**Beatrice Offshore Windfarm
Environmental Statement Addendum**

**Annex 9B Physical Processes
Consultation Surfers Against Sewage**

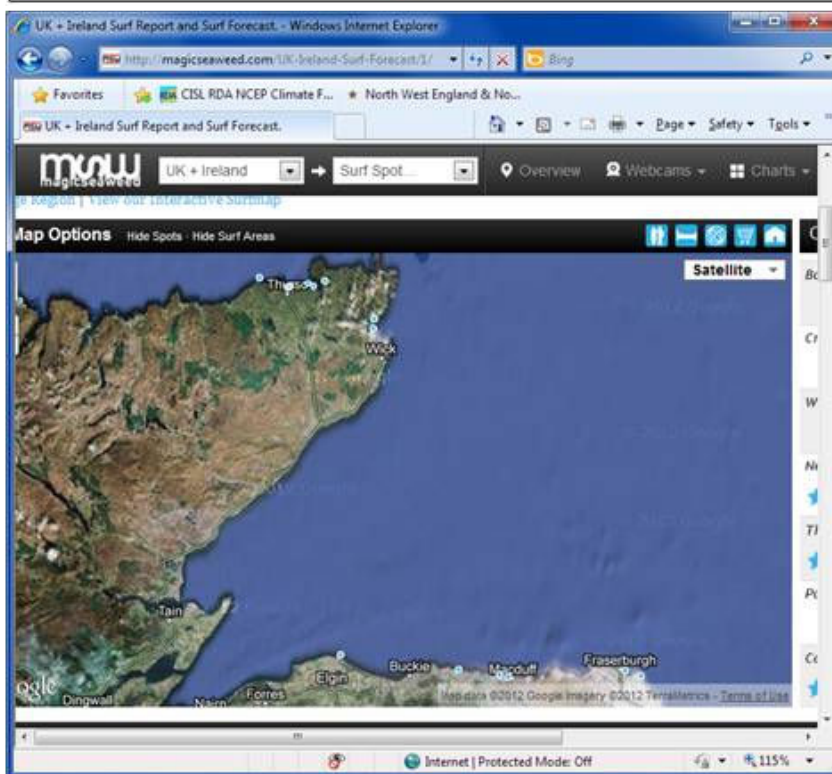
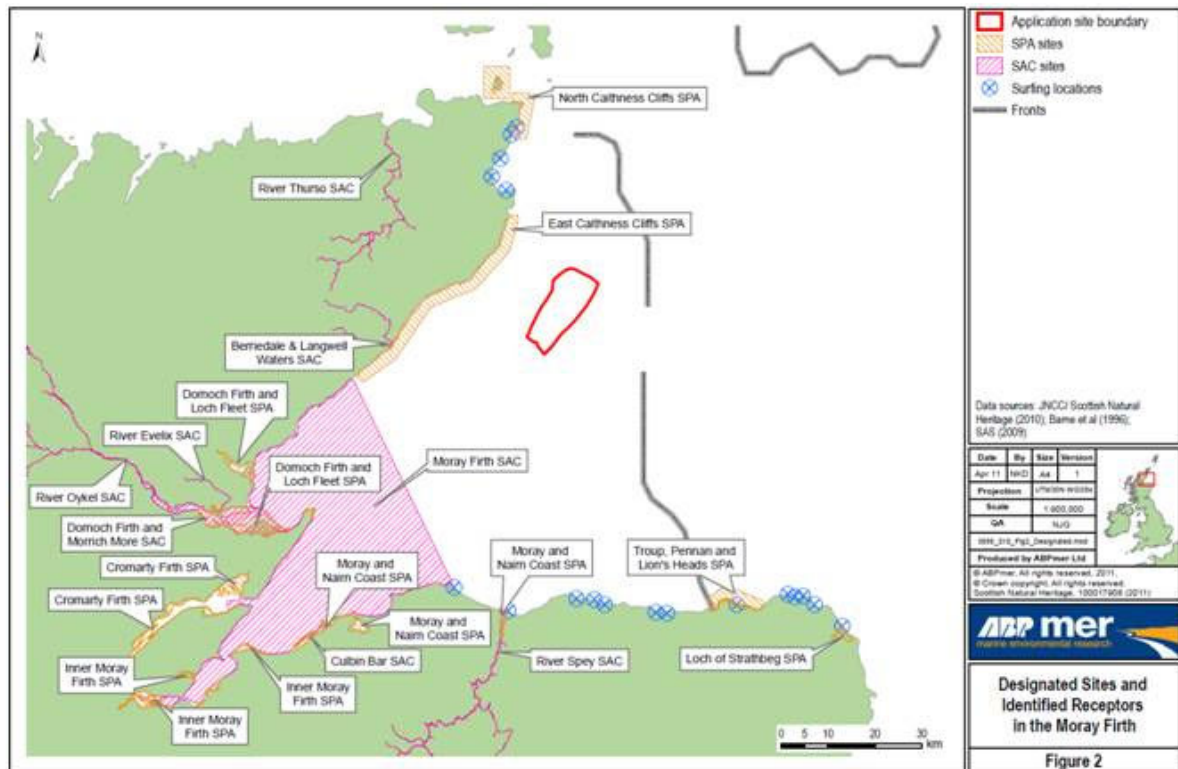
1. Whether all relevant surfing locations have been included in the assessment.
2. Whether the cable landfall will significantly interfere with the quality of surfing waves or access to surfing locations.

You have asked for the opportunity to consult with a small number of respected individuals in the local surfing community to confirm that all key surfing venues have been considered. We would welcome further comments, however, in the interest of a timely conclusion please can you also consider the information below and provide a provisional response if you feel that is supported and appropriate.

We will give further consideration to recognised and relevant surfing venues if they are not presently included in the assessment. As shown below, I trust that there should not be any major omissions. Please note that effects of the wind farm on waves do not extend outside of the Moray Firth.

For reference, the figure [below left] shows the locations assessed in the ES (blue circles with crosses, as identified in the Stormrider Guide for Europe) and the figure [below right] shows surf spots presently highlighted on Magic Seaweed. The assessment provided in the ES is shown to include all of (and more than) the surf spots presently identified on Magic Seaweed.

Ideally, we would like to consider the above as a demonstration that all relevant locations have been assessed. If you agree, could we (provisionally) close this comment now?
